**Public Contract
Application for
Contractual Changes**

Contract Change Order # 4

Project Name: Elam Park Phase 1 Project Number: 196031
 Project Location: Elam Park off Florence St. Date of Application: Friday, December 29, 2023
 Contractor: Voy Construction, LLC. Submitted By: Sean Ross

KB311-SSWM Vertical Stainless Steel Surface-Mounted Baby Changing Station

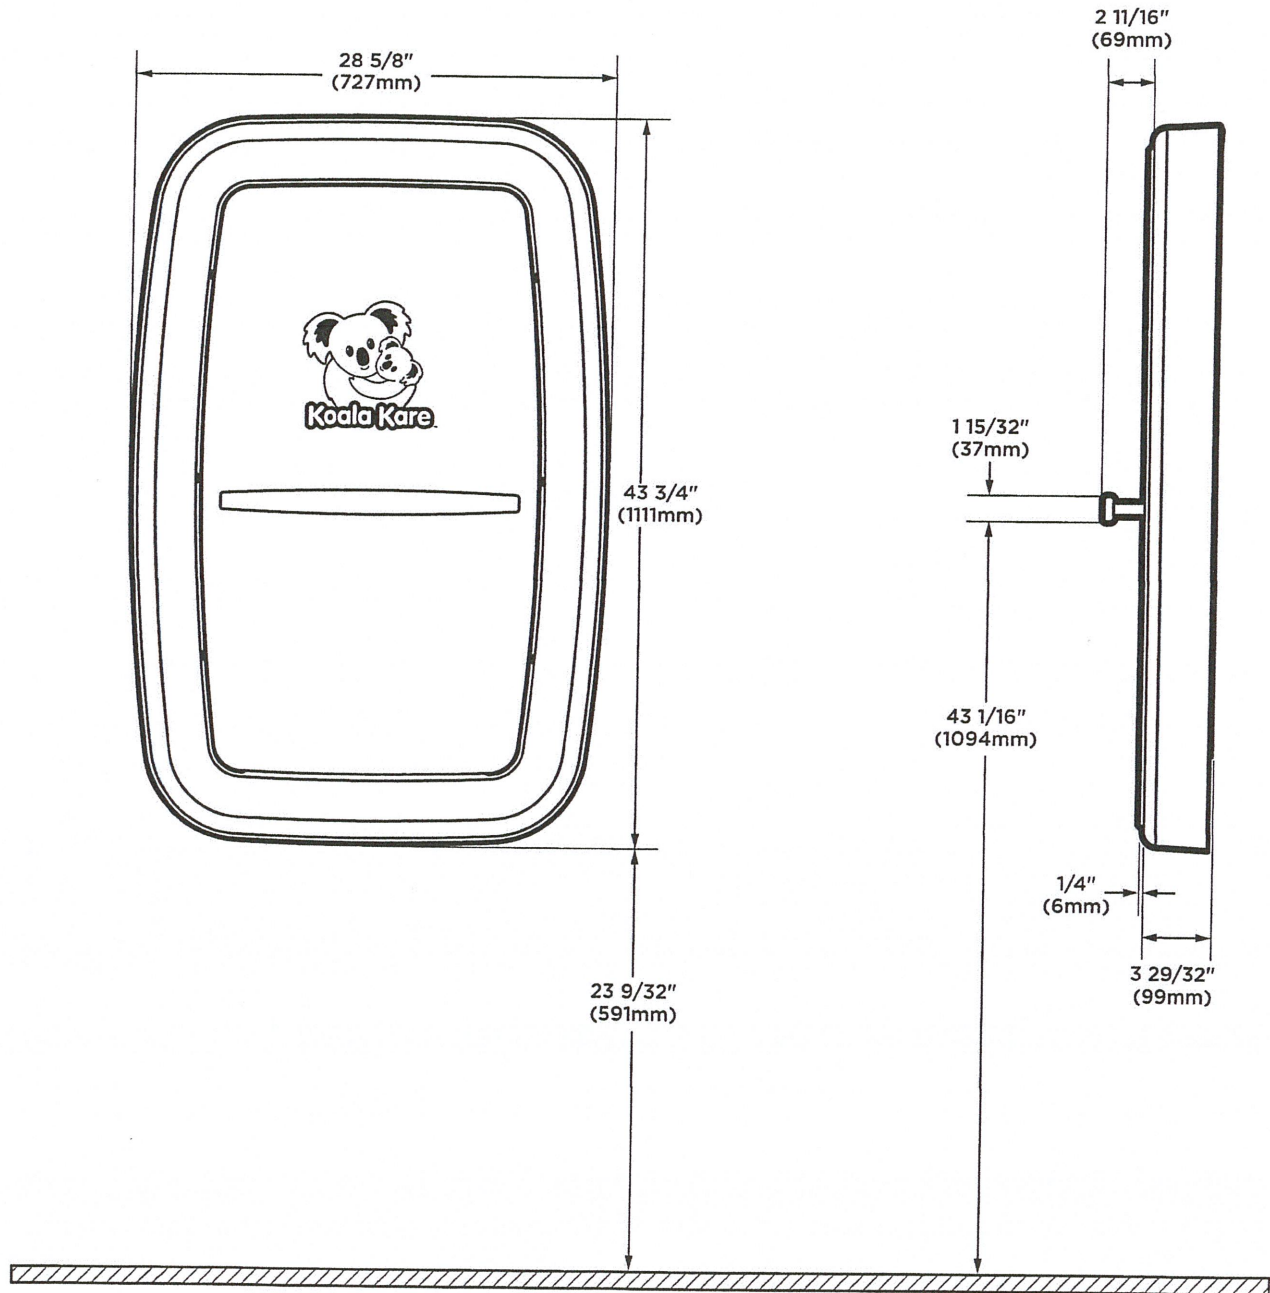
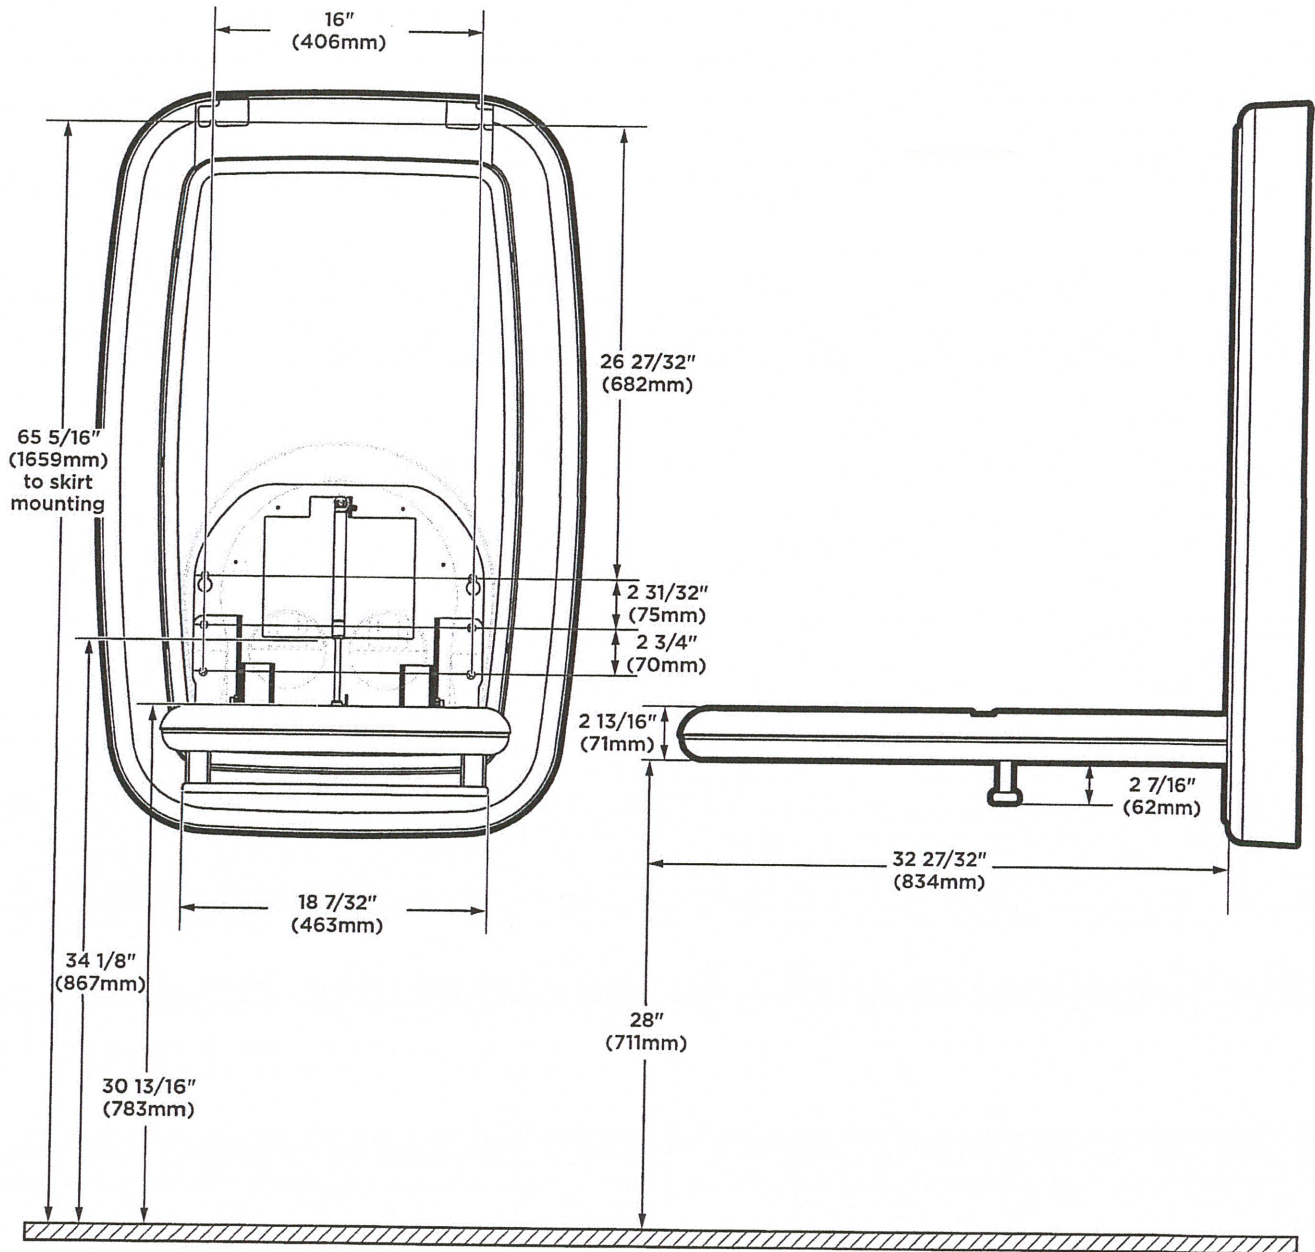
A101 shows both an Adult Changing Table and Baby Changing Station to be installed on the East wall of Room 102. During installation it was noted that both of these changing tables could not be installed in the horizontal orientation as shown and specified. At the request of the City of Broken Arrow, pricing was to be provided to change the Baby Changing Station from horizontal to vertical style.
